# Access Compliance Report

## Public Rights-of-Way

### (Curb Ramps)

Intersection ID: 2801	Main Street: BELL'S_MILL_DR	Cross Street: DUNOON_LN	Location: SE
ADA ID: E8BB281B03FD	Ramp Type: PerpDiag	Initial Pass/Fail: Fail	Overall Compliance: No
Severity Score: 33.75			
Codes/Mitigation Info/Possible Solution		Field Measurements/Component Compliance

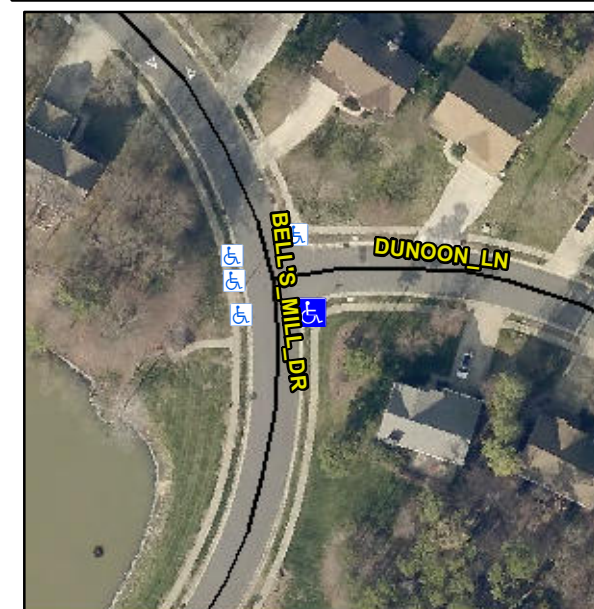
**Not Found, R304.5.1, R304.2.2**

Compliance	Description	Data	Compliance	Description	Data
N/A	Ramp Length (in)	43.0	No	Ramp Slope (%)	15.0
No	Ramp Width (in)	41.0	Yes	Ramp XSlope (%)	1.8
N/A	Flare Type LT	N/A	N/A	Flare Type RT	N/A
N/A	Flare Slope LT (%)	N/A	N/A	Flare Slope RT (%)	N/A
N/A	Flare Traversable LT?	N/A	N/A	Flare Traversable RT?	N/A
N/A	Landing Length (in)	N/A	N/A	DWS Provided?	N/A
N/A	Landing Width (in)	N/A	N/A	DWS Contrast?	N/A
N/A	Landing Slope (%)	N/A	N/A	DWS Length (in)	N/A
N/A	Landing X Slope (%)	N/A	N/A	DWS Full Width?	N/A
N/A	Landing Curb? (Y/N)	N/A	N/A	DWS Offset (in)	N/A
N/A	Shared Landing?	N/A			
N/A	Gutter Ponding?	N/A	N/A	Gutter Slope (%)	N/A
N/A	Gutter Lip Ht (in)	N/A	N/A	Gutter X Slope (%)	N/A
N/A	Painted X Walk1?	No	N/A	Painted X Walk2?	No
	X Walk 1 Direction	To N		X Walk 2 Direction	To W
N/A	X Walk 1 Width (in)	N/A	N/A	X Walk 2 Width (in)	N/A
	X Walk 1 Slope (%)	5.3		X Walk 2 Slope (%)	3.1
	X Walk 1 X Slope (%)	2.2		X Walk 2 X Slope (%)	4.5

**Remove & Replace Curb Ramp With Two New Directional Ramps or Equivalent.**
